MFN 08-889

Docket No. 52-010

Subject: **Response to Portion of NRC Request for Additional Information Letter No. 233 Related to ESBWR Design Certification Application – Radioactive Waste Management Systems – RAI Numbers 11.0-1 and 11.3-13**

**Response to Portion of NRC Request for
Additional Information Letter No. 233
Related to ESBWR Design Certification Application
Radioactive Waste Management Systems
RAI Numbers 11.0-1 and 11.3-13**

Figure 11.3-1. Offgas System

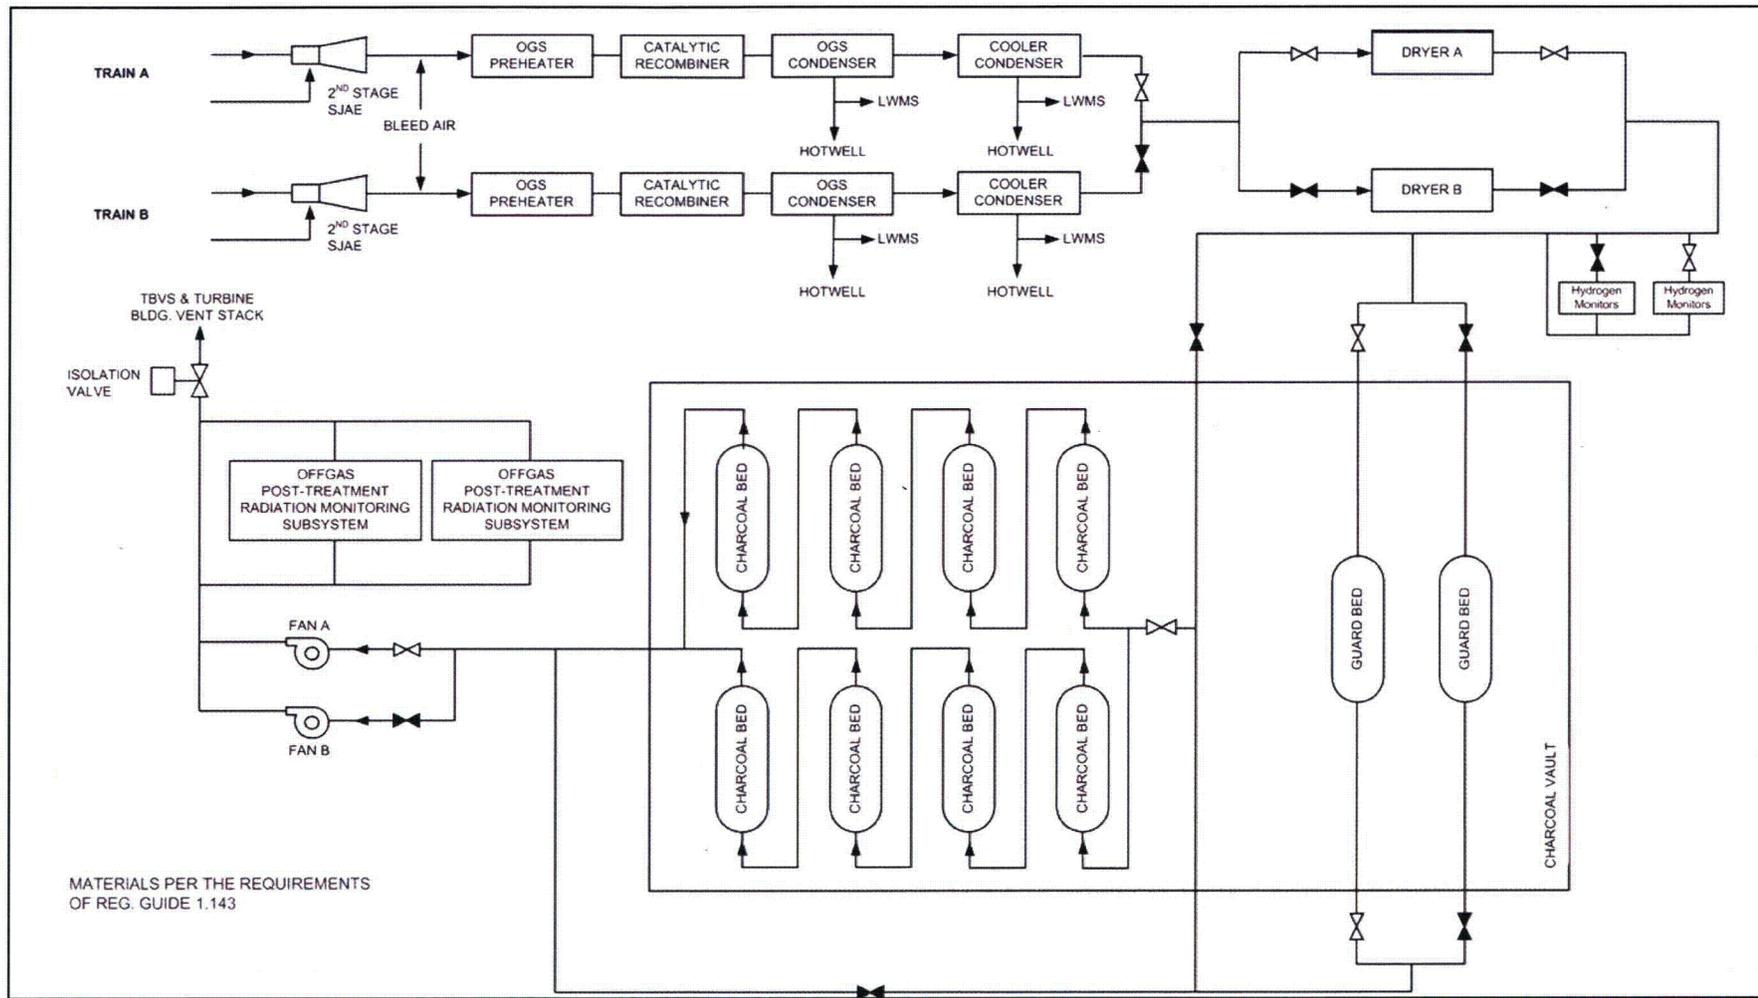
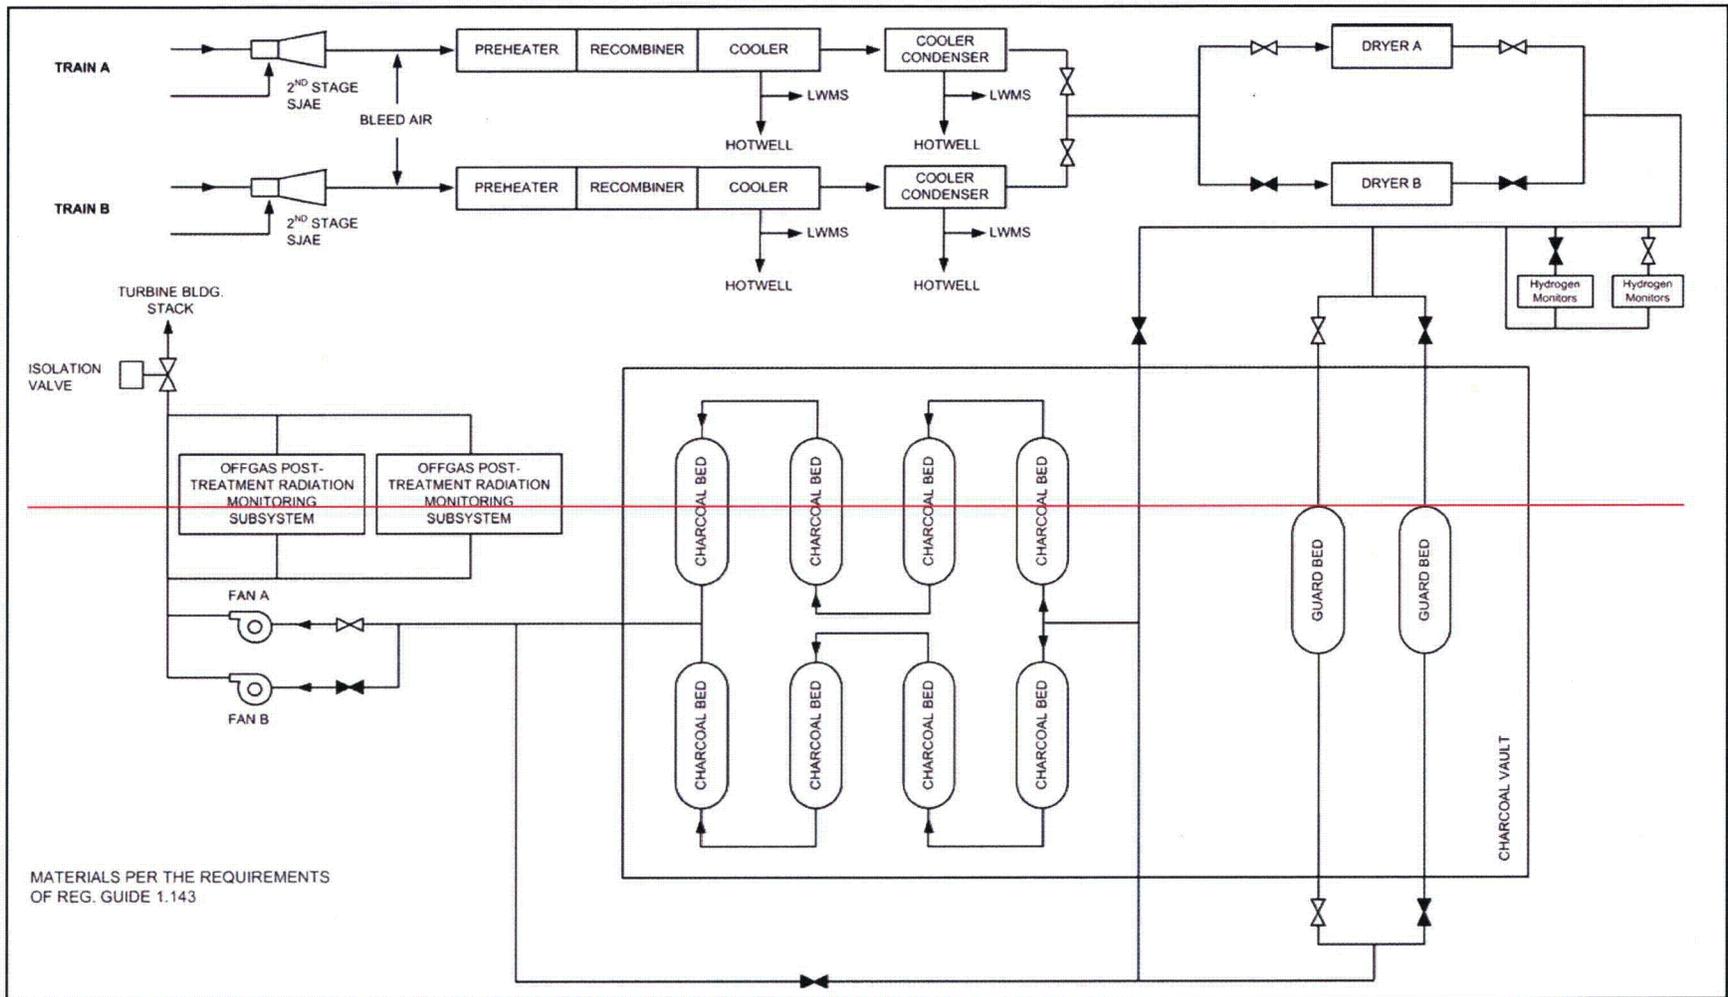
- (b) There is TEMA C code requirement for the Cooler-condenser but not for the Preheater and Catalyst (both are S&T Heat Ex.). Why?*
- (c) A review of DCD Tier 2, Revision 5, Figure 11.3-1., Offgas System flow diagram shows Preheater- Recombiner Cooler as one assembly. This is rather confusing since per DCD 11.3.2.2 the Recombiner assembly includes Preheater, Catalyst and Condenser sections. The applicant needs to clarify this and be consistent with the text and flow diagram.*

- (d) The same flow diagram, Figure 11.3-1, shows eight (8) charcoal beds and two (2) guard beds. Table 11.3-2 calls for 10 vessels "filled with activated charcoal". The applicant needs to clarify and be consistent with the flow diagram.*

- (f) DCD Tier 2, Revision 5, Figure 11.3-1., Offgas System, has a note Material per requirements of Reg. Guide 1.143. Table 1 of this guide is very specific as to material type and grade required for pressure retaining parts (i.e., 304 SS or 316SS, SA 36, or 516 Gr. 70 CS, etc.). DCD Tier 2, Revision 5, Table 11.3-2 is very general as to the materials description. The applicant needs to provide more detail on materials used in this system.*

- c) Nomenclature throughout the text of Section 11.3 is changed for consistency relative to this RAI concern. These changes occur in Tier 2, sub-sections 11.3.2.2, 11.3.2.5.1, 11.3.2.5.9, 11.3.2.6.7, 11.3.2.6.11, Table 11.3-1, Table 11.3-2, Table 11.3-3, and Figure 11.3-1. Tier 2, Figure 9.4-8, and Tier 1, Figure 2.16.2-6 is revised as attached to indicate a flow path from the OGS to the Turbine Building Vent Stack.

- d) All ten Charcoal Adsorber vessels contain activated charcoal. To clarify this concern about the number and function of the vessels, Table 11.3-2 is revised as attached.

Pressure retaining components are required to meet ASME Sections II and VIII in accordance with Reg Guide 1.143, Table 1. During the detail design phase, specific material specifications will be determined for each component pending input from the supplying vendors.
